# St Marys Site Establishment Construction Traffic Management Plan

Sydney Metro Western Sydney Airport Station Boxes and Tunnelling Works

<b>Project number</b>	WSA-200-SBT
<b>Document number</b>	SWMSASBT-CPG-STM-SN100-TF-PLN-000001
<b>Revision date</b>	August 23
<b>Revision</b>	06

Subject	Sydney Metro WSA - SBT – Construction Traffic Management Plan (CTMP) – St Marys Site Establishment (Rev. 05) – Updated to include Appendix 12 covering secondary haulage route – Comment Close out & CJP Approval
<div>–</div> <div>–</div> <div>Comment No. 120</div> <div></div>

FIGURE 10.12.10. TYPICAL CROSS SECTION ALONG STATION 0+1

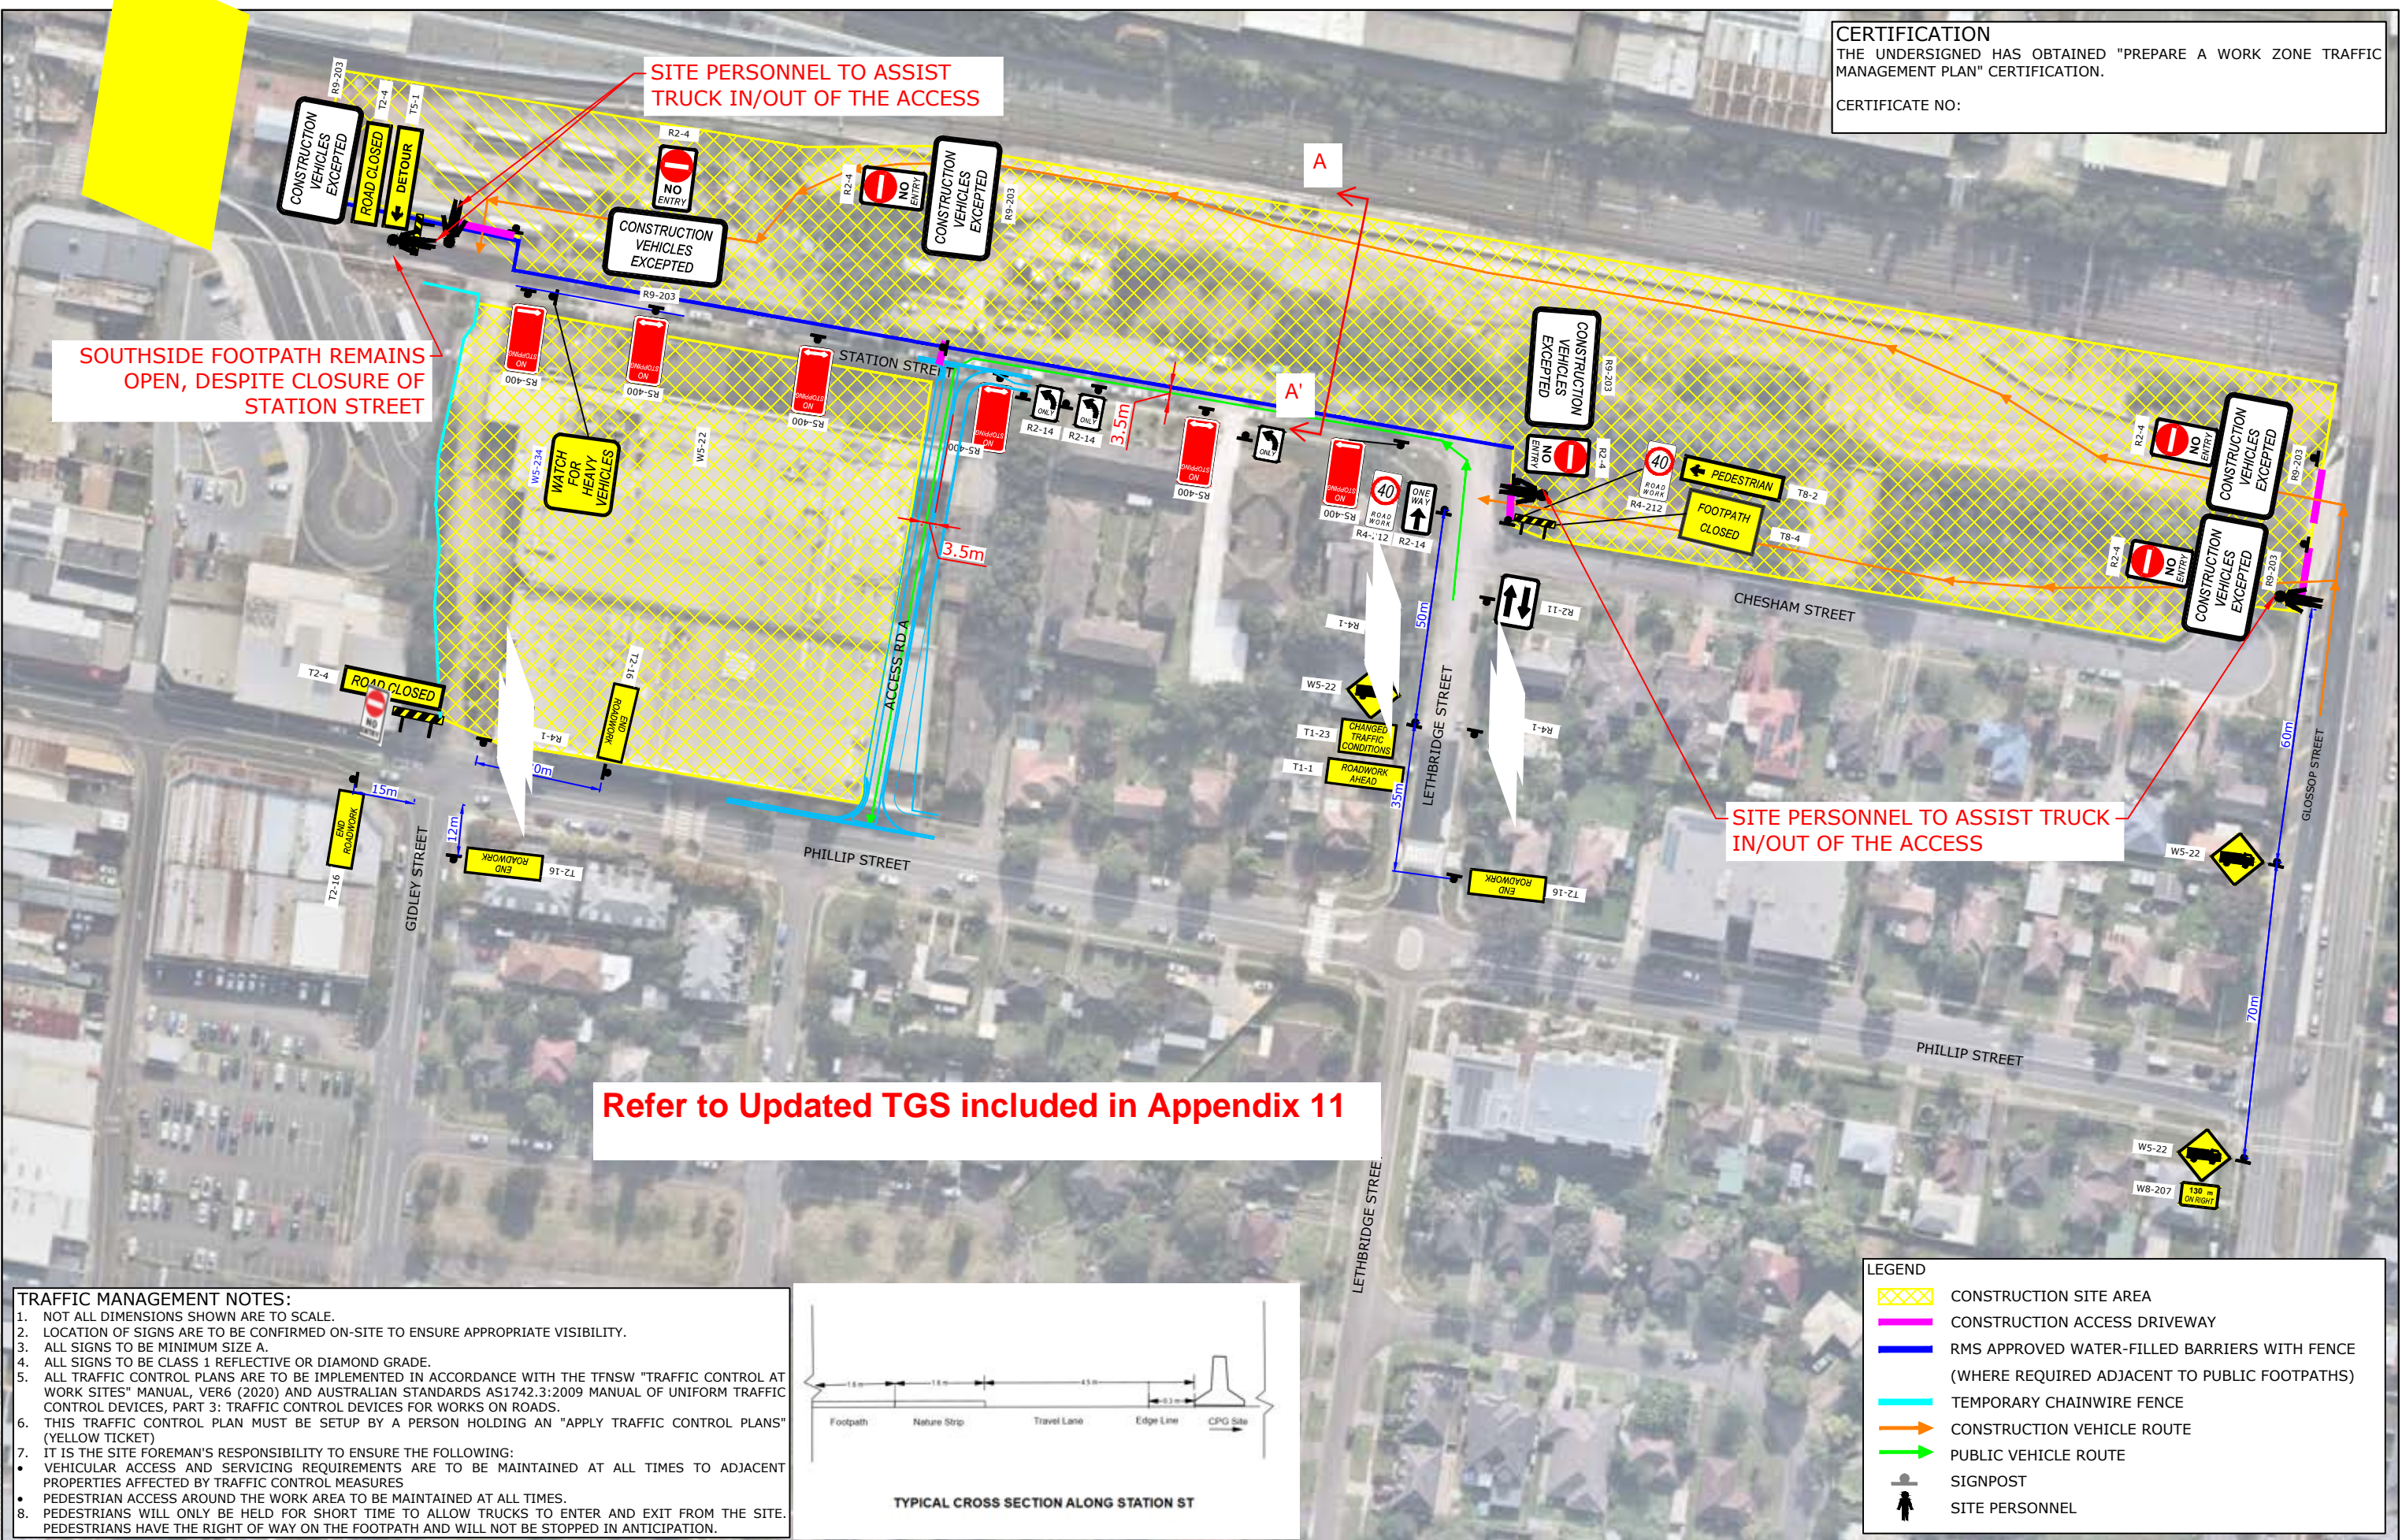
Response <sup>x</sup>	Status <sup>y</sup>	
General					
1.	<b>Fencing on Water Filled Barrier</b> Legend in drawing number 22063CAD002, Figure 1 indicates the use of RMS approved water filled barrier with fence (where required adjacent to public footpaths) – (dark blue line). It should be noted that water filled barriers are not crash tested with fencing and as such it may not function as intended. It is also unclear from the drawing as to where the fencing will be installed as there is a light blue line which is also shown to be fencing.	Clarify where fencing will be installed and avoid installation on top of water filled barrier.  Risk: Low given that operating speeds on the subject roads will be very low.	Drawing amended	Closed

DOCUMENT NO.	TITLE	VER	STATUS	NO.	DATE	COMPANY	RAISED BY	REVIEW DOC. NO.*	DOCUMENT REF*	DEED REF*	COMMENTS / RESPONSE	COMMENT CATEGORY*	CLOSED OUT
				15.01	29/06/2022	CPG		SMWSASBT-CPG-STM-SN100-TF-PLN-000001	22063CAD002 FIGURE 1		Cross section now includedNo Stopping signs are new - PCC have advised that this proposal does not need to go to LTC. Station St is licenced to Sydney Metro for the duration of works and therefore changes will be approved through CTMP process approved by CJPResidents have on site parking. It is noted that the EIS also removed this parking. Refer to section 9. W5-22 required on all approaches unless advised by Sydney Metro. Truck volumes on site satisfies requirements for installation of signs included in table 6-10 of TCaWSThe road is closed with the hazard marker on a barrier board as shown on the drawing. In the event that Access Road A is not available, the public will be able to use the existing Station Access Plaza road (Gidley St) as noted in the text (section 3.2) - 2 drawings are now included showing this No pedestrian access will be provided through the Station Access Plaza road (Gidley Street) when Access A road is in operation. As noted above two drawings have now been providedCurrent surface will within the site as marked-up on updated drawing included in the CTMP. Station St will be closed for general traffic at Access	Potential Non-Compliance	Y

SMWSASBT-CPG-STM-SN100-TF-PLN-000001	22063CAD002 FIGURE 1			Potential Non-Compliance	Y
				16	30/05/2022	SMD		SMWSASBT-CPG-STM-SN100-TF-PLN-000001	22063CAD002 FIGURE 2		Figure 1 shows barriers on Station street and chain wire fence. Figure 2 appears to be swept path drawings for the same area, but the barriers and fencing are not shown. Please review and update the Figure 2	Potential Non-Compliance	Y
								SMWSASBT-CPG-STM-SN100-TF-PLN-000001	22063CAD002 FIGURE 2			Potential Non-Compliance	Y

16.01	29/06/2022	CPG		SMWSASBT-CPG-STM-SN100-TF-PLN-000001	22063CAD002 FIGURE 2		Drawing amended	Potential Non-Compliance	Y
								SMWSASBT-CPG-STM-SN100-TF-PLN-000001	22063CAD002 FIGURE 2			Potential Non-Compliance	Y
				17	30/05/2022	SMD		SMWSASBT-CPG-STM-SN100-TF-PLN-000001	SBT-TGS-GEN-PED-0001		This is an example that does not reflect any location at this site. Even the site is labelled as "an example site". Update.	Potential Non-Compliance	Y
								SMWSASBT-CPG-STM-SN100-TF-PLN-000001	SBT-TGS-GEN-PED-0001			Potential Non-Compliance	Y

TITLE : WSA-TGS-STA-ALL-1201

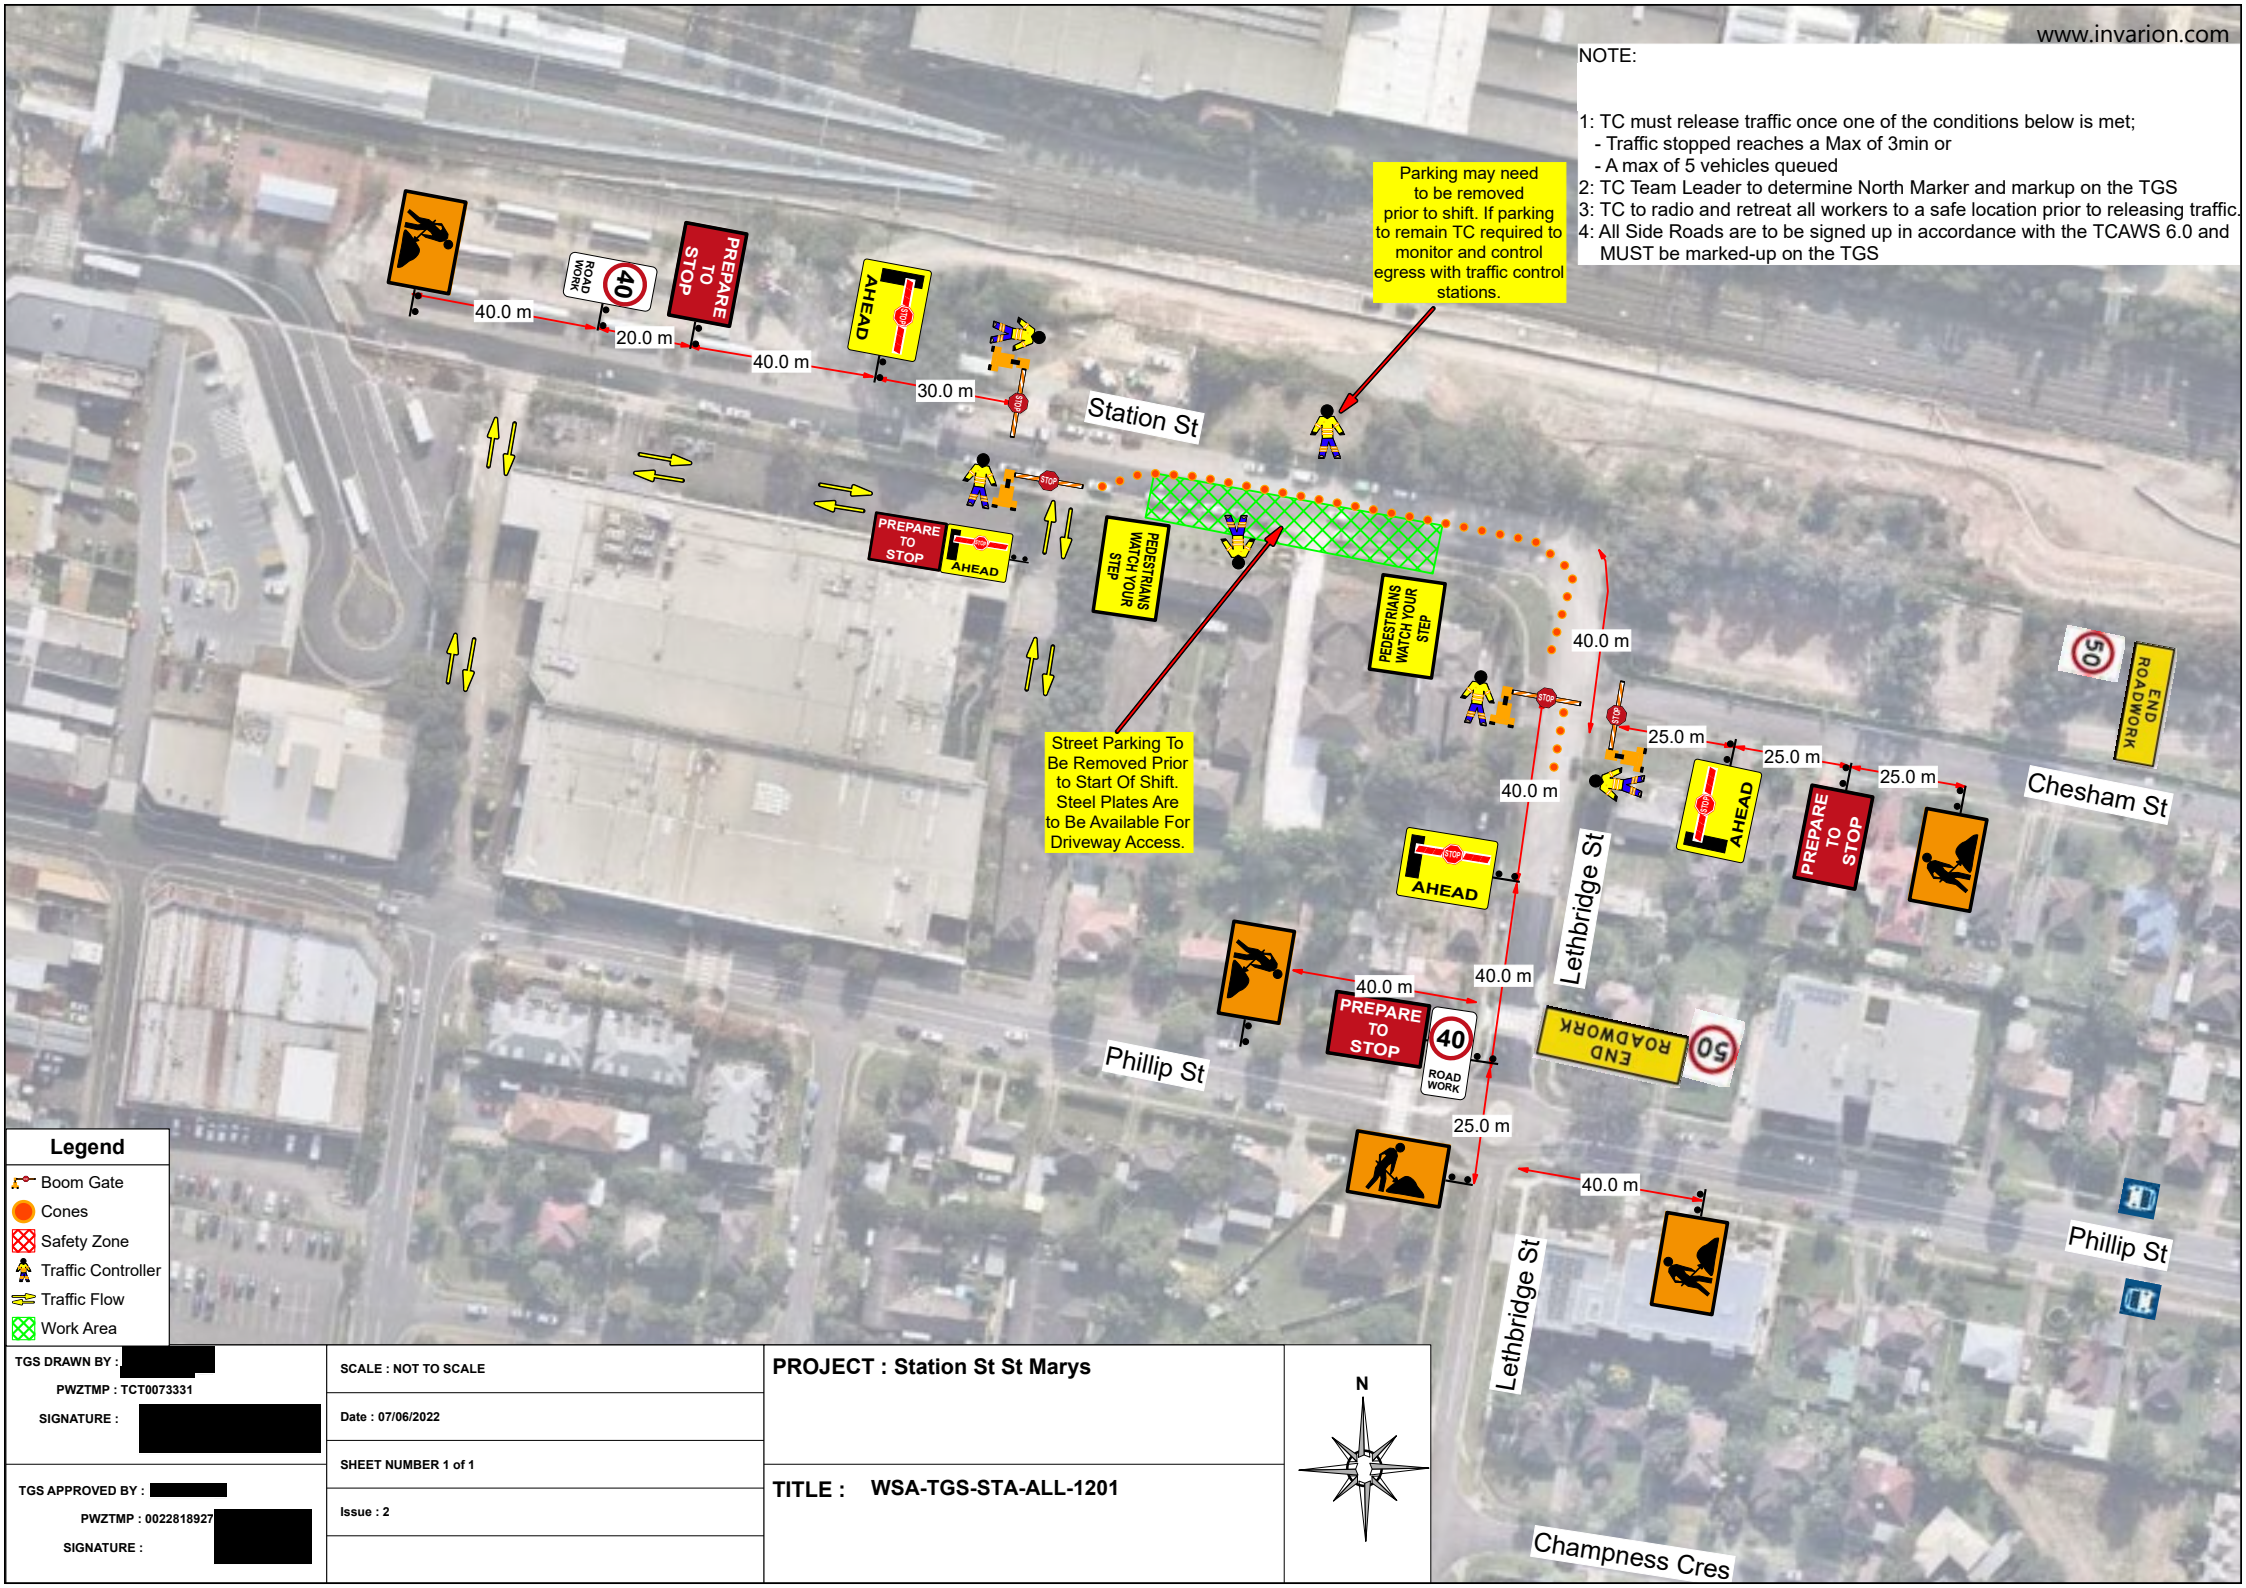
Audit Point	Treatment Option	Responder: [REDACTED]	
			Response <sup>x</sup>	Status <sup>y</sup>
WSA-TGS-STA-ALL-1201				
6.	<p><b>Pedestrians</b></p> <p>It is noted that pedestrians have to traverse through the work area. It is not obvious from the drawing as to how pedestrian movements though the work area is to be managed. It is likely that the traffic controller would guide pedestrians through the work area.</p>	<p>Review and confirm.</p> <p>Risk: Low</p>	Confirmed	Closed

Location:	HOBART STREET		CERTIFICATE NO:	0022818927
TRAFFIC GUIDANCE SCHEME DATE: 13/06/2022	TGS No:	WSA-TGS-A-GOS-NB-0201		SIGNATURE:	<div></div>
				PLAN CHECKED BY:	<div></div>
				CERTIFICATE NO:	07

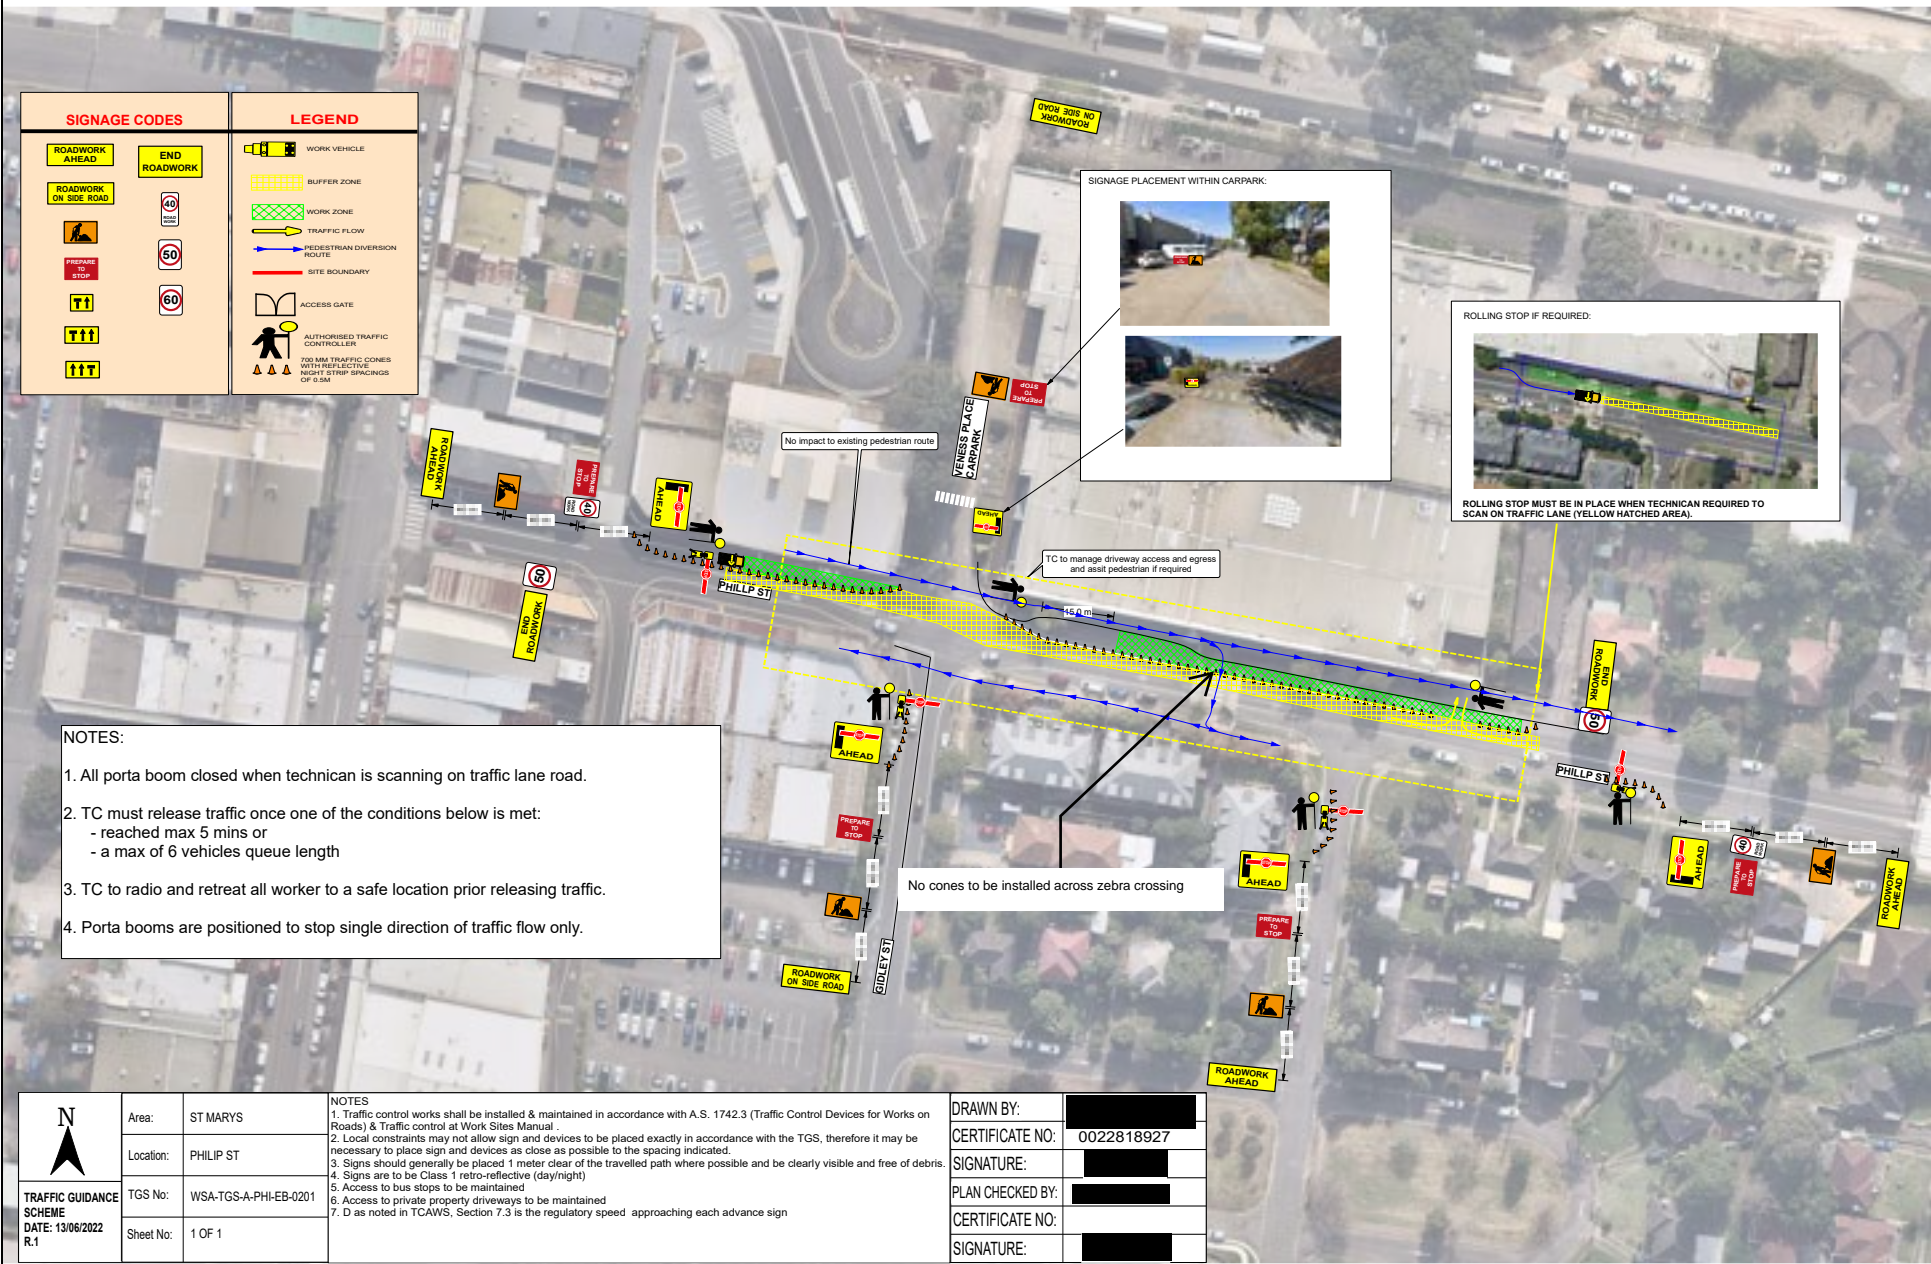
Sydney Metro Western Sydney Airport Station Box and Tunneling Package					St Marys Site Establishment
	Audit Point	Treatment Option	Responder: [REDACTED]		
			Response <sup>x</sup>	Status <sup>y</sup>	
WSA-TGS-A-GOS-NB-0201					
6.	<b>Lane Merge</b> There are no lane status signs advising drivers of the termination of the kerbside lane and no physical merge taper on Glossop Street northbound.	Review and include measures to clearly define the kerbside lane termination and merge.  Risk: Low to Medium	Signs installed	Closed

57.01	29/06/2022	CPG		SMWSASBT-CPG-STM-SN100-TF-PLN-000001	WSA-TGS-A-HOB-ALL-0201, WSA-TGS-A-GOS-NB-0201	NA	Document amended for WSA-TGS-A-HOB-ALL-0201. WSA-TGS-A-GOS-NB-0201 is now within the construction only lane and does not impact live traffic lanes.	Observation	Y
								SMWSASBT-CPG-STM-SN100-TF-PLN-000001	WSA-TGS-A-HOB-ALL-0201, WSA-TGS-A-GOS-NB-0201	NA		Observation	Y
				58	3/06/2022	SMD		SWMSASBT-CPG-STM-SN100-TF-PLN-000001	3.1 Figure 6 & Appendix 1	NA	Does Figure 6 show the one way Station St arrangement or an interim state to facilitate Plaza and Bus Interchange demolition prior to transition to one way along Station St. The site hoarding and fencing arrangement will be materially different than what is shown in Figure 6 to facilitate site establishment north of Station St. The site establishment drawing package shows site hoarding running east west along Station St to facilitate demolition of the northern portion of Station St itself. Would a second stage Figure be appropriate to better align with construction site arrangement. Note this would also better align with the Stage 2 Construction Works TCP included in Appendix 1	Potential Non-Compliance	Y
